## **Access Compliance Report Public Rights-of-Way** (Curb Ramps)

Intersection ID: 14400 Main Street: BERKELEY\_AV Cross Street: DILWORTH\_RD Location: SW Ramp Type: Directional1 **Overall Compliance: No ADA ID: 14FAD27D170D** Initial Pass/Fail: Fail **Severity Score:** 25

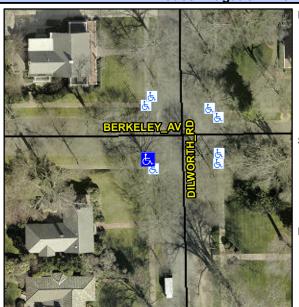
Field Measurements/Component Compliance								
Comp	Data	Comp	liance Description	Data				
N/A	Ramp Length (in)	26.0	N/A	Grade Break?	N/A			
Yes	Ramp Width (in)	72.0	N/A	Grade Break Slope (%)	0.0			
Yes	Ramp Slope (%)	7.0	N/A	Grade Break XSlope (%)	0.0			
No	Ramp XSlope (%)	7.0						
N/A	Flare Type LT	N/A	N/A	Flare Type RT	N/A			
N/A	Flare Slope LT (%)	N/A	N/A	Flare Slope RT (%)	0.0			
N/A	Flare Traversable LT?	N/A	N/A	Flare Traversable RT?	N/A			
N/A	Landing Length (in)	0.0	N/A	DWS Provided?	N/A			
N/A	Landing Width (in)	0.0	N/A	DWS Contrast?	N/A			
N/A	Landing Slope (%)	0.0	N/A	DWS Length (in)	N/A			
N/A	Landing X Slope (%)	0.0	N/A	DWS Full Width?	N/A			
N/A	Landing Curb? (Y/N)	N/A	N/A	DWS Offset LT (in)	N/A			
N/A	Shared Landing?	N/A	N/A	DWS Offset RT (in)	N/A			
N/A	Gutter Ponding?	0.0	N/A	Gutter Slope (%)	N/A			
N/A	Gutter Lip Ht (in)	1.0	N/A	Gutter X Slope (%)	N/A			
N/A	Painted X Walk1?	No		Road Slope (%)	8.5

X Walk 1 Direction	To NW		Road X Slope (%)	2.3			
	X Walk 1 Width (in)	N/A		Clear Space?	N/A			
	X Walk 1 Slope (%)	8.5	N/A	Clear Space to XWalk (in)	N/A			
	X Walk 1 X Slope (%)	2.3	N/A	Storm Grate/Utility Hazard?	N/A			
N/A	Ramp inside XWalk1?	N/A		Storm Grate/Utility Type				
N/A	Any Obstructions?	N/A			N/A			
	Obstruction Type		Yes	Surface Condition? (G/P)	Good			
		N/A	N/A	Curb Slope (%)	25.7

Possible Solutions:
A THE PARTY OF THE	Remove & Replace Entire Ramp.
100	Surveyor Notes:
1	N/A
	PROW/ADA:
1	R304.5.3
